## Recall Notice

**Recall #:** 100715

Inform Aluma dealers and owners that 5410T tilt trailer may have missing weld that may contribute to a failure of the trailer's tongue weldment.

Figure 1

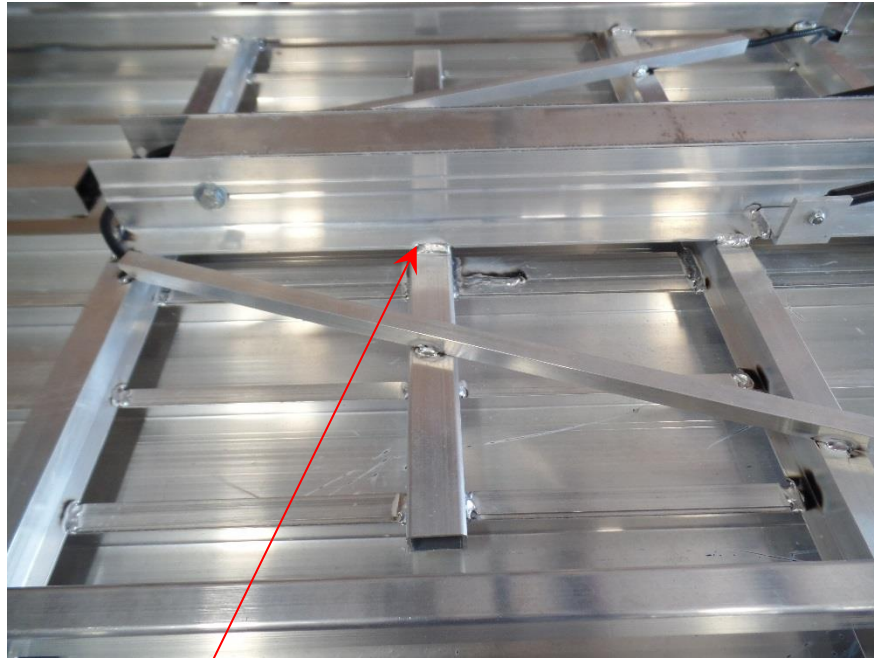
- 2.0 Inspect all welds and base material on tongue retainer and trailer frame to ensure no signs of damage has occurred. See Figure 1, 2 and 3. Prepare surface areas that are to be welded. Person performing retrofit should be qualified and proficient aluminum welder. **Caution:** Use appropriate PPEs when preparing surface and welding.

Figure 2

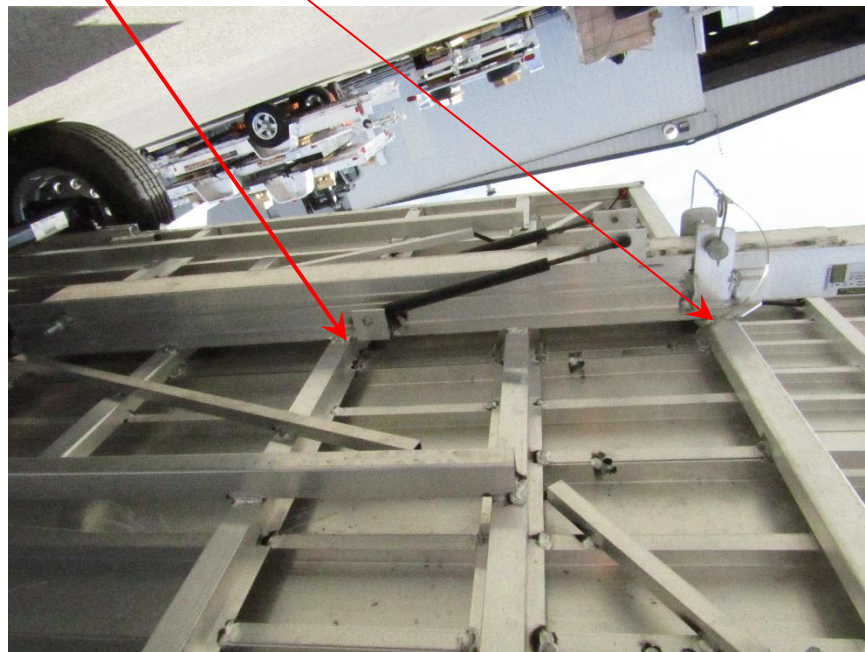
Inspect weld and base material

Figure 4

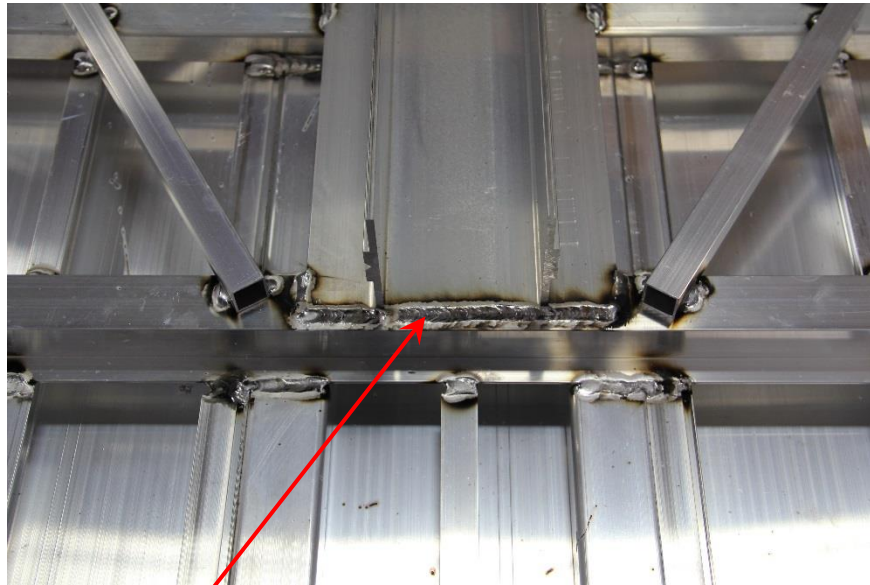
- 3.0 Figures 4 and 5 shows different orientation of tongue retainer. If welds are missing, then add .25" fillet welds as shown See Figure 4 and 5. **Note:** Ensure that wiring harness is not damaged during welding.

If weld is missing add .25" fillet welds as shown

Figure 6

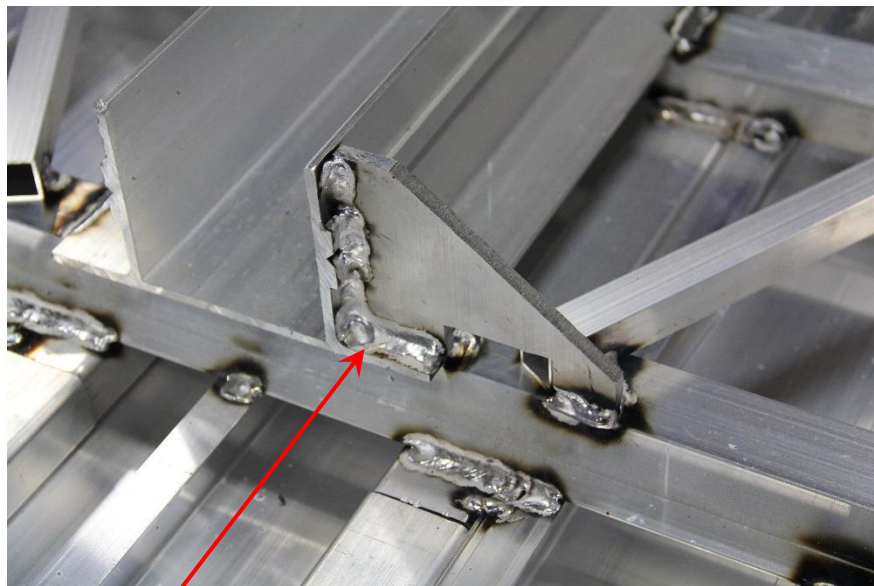
- 4.0 Add 2 gussets and .25" fillet weld as shown in Figure 6 and 7.
- 5.0 Verify work has been completed and all tools and hardware is secured. Raise trailer and remove jack stands.

Add 2 gussets and .25" fillet welds as shown.  
One gusset on each side of tongue retainer.
